311 EAST 6<sup>TH</sup> AVENUE (COMPLETE APPLICATION)  
DE417971 - ZONE IC-3

**DEVELOPMENT PERMIT STAFF COMMITTEE MEMBERS**

**DEVELOPMENT PERMIT STAFF COMMITTEE RECOMMENDATION: APPROVE**

LEVEL L1 PLAN  
 311 EAST 6TH AVENUE  
 DATE AUGUST 27, 2014  
 JOB: 33794  
 DE417971  
 1/8" = 1'-0"  
 1.05

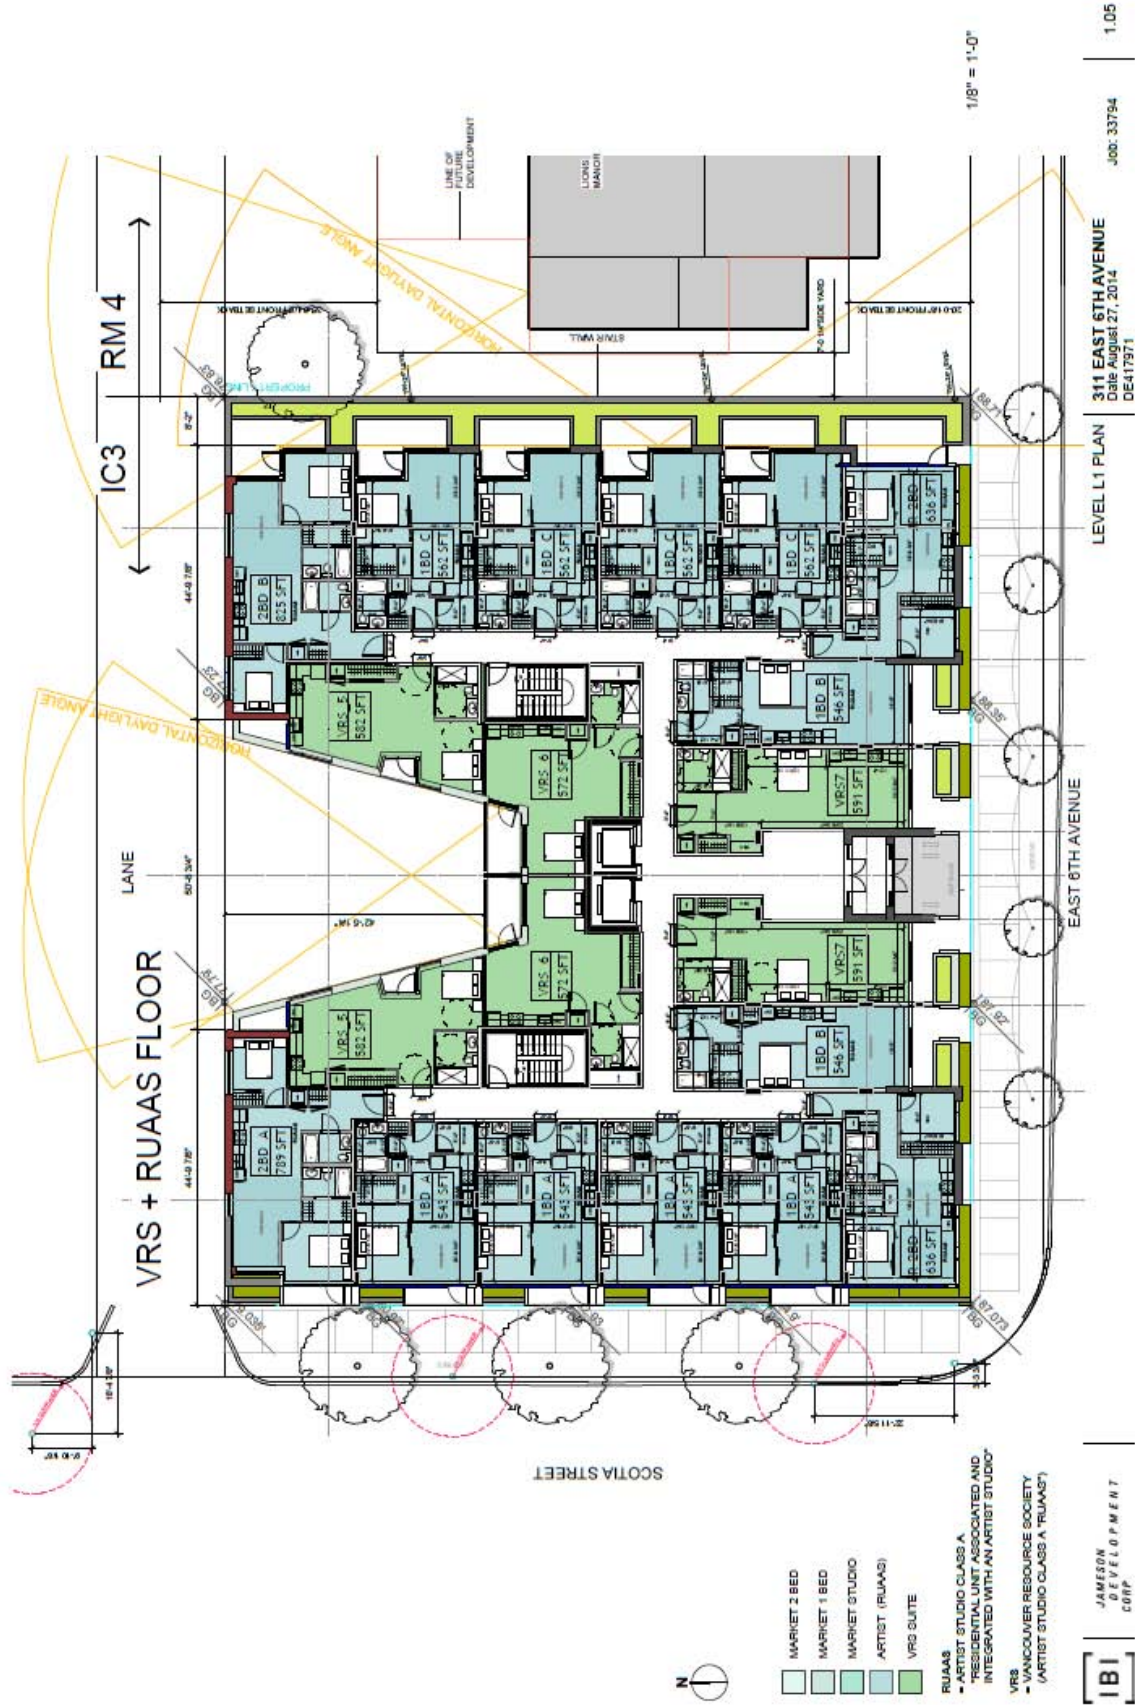
1.4 design development to reduce the height impact of concrete wall, northeast building corner at parking entry;

**Note to Applicant:** Consider an opening having an architectural screen/grille or stepped planters having trailing planting.

Less well-resolved is the impact and scale of the concrete building base at the parking entry in the northeast corner of the site. Given the +/- 4.1 m (13'-8") building face, and with the additional guard height required, this expansive aspect of the concrete parking structure impacts both the lane and neighbour to the east. Efforts should be made to improve both visual interest and pedestrian scale as experienced from the lane and adjacent residential development. These concerns are covered under See Condition 1.4.

1/8" = 1'-0"  
 LEVEL L6 PLAN  
 311 EAST 6TH AVENUE  
 Date August 27, 2014  
 DE417971  
 Job: 33754  
 1.09

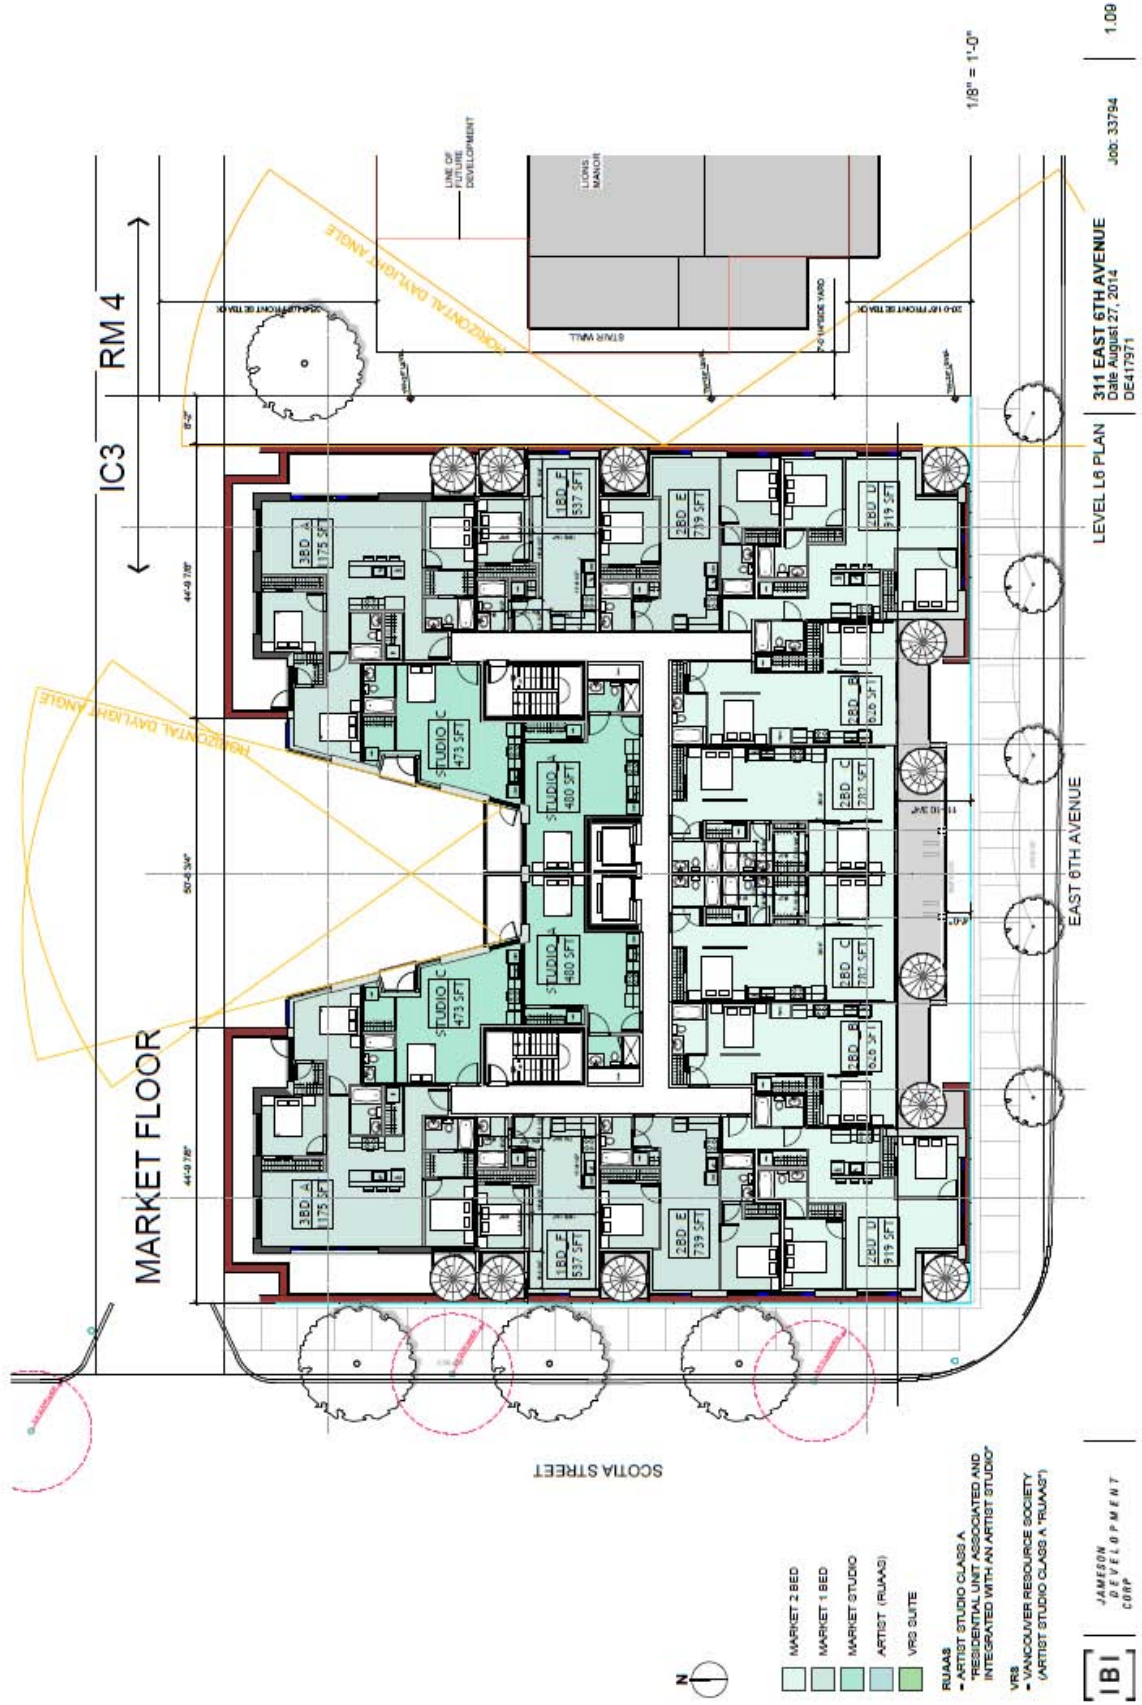
- iii. design development to enhance privacy separation between unit roof decks on Level 6;

**Note to Applicant:** Consider an integrated assembly of planters and screens for this purpose. Note screens should be pulled back from the parapet edge.

#### A.1.4 revision to the drawings on pages 1.09 and 1.10 to include the following elements in plan view:
